Service Bulletin

PRELIMINARY INFORMATION

Subject: Vibration Or Shudder On Acceleration From A Stop

Models: 2013-2016 Cadillac XTS with All Wheel Drive (AWD)
2014-2016 Buick Regal with All Wheel Drive (AWD)

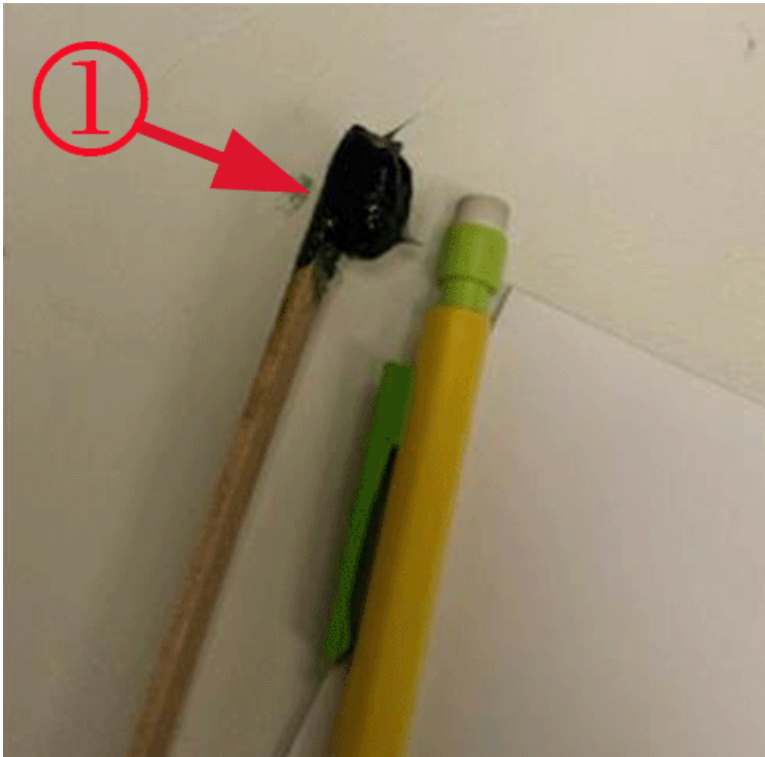
If this condition is encountered inspect the splined area on the right half shaft and the mating splines on the Intermediate drive shaft.

If the splines are damaged on the intermediate drive shaft the shaft would need to be replaced and the Front Wheel Drive Intermediate Shaft/Bearing installation procedure should be followed to ensure the bearing is installed in the correct orientation.

If the splines in the half shaft are damaged, you must replace the half shaft AND install a new retaining ring P/N 90223082.

If the splines are not damaged replace the right hand axle shaft barrel cross section ring, P/N 22727024, with round cross section retaining ring, P/N 90223082.

Remove all grease from the transfer case intermediate drive shaft (IDS) internal splines and axle shaft splines. Apply total of 1 gm grease on IDS splines: 0.5 gm in two 120 degree quadrants each, 180 degree apart. Ensure the other two adjacent quadrants have splines free of grease. Apply grease within 15 mm of leading spline edge and do not apply in the retaining ring groove.

1/2 gm of grease is shown below. Do not exceed 1.5 gm total.
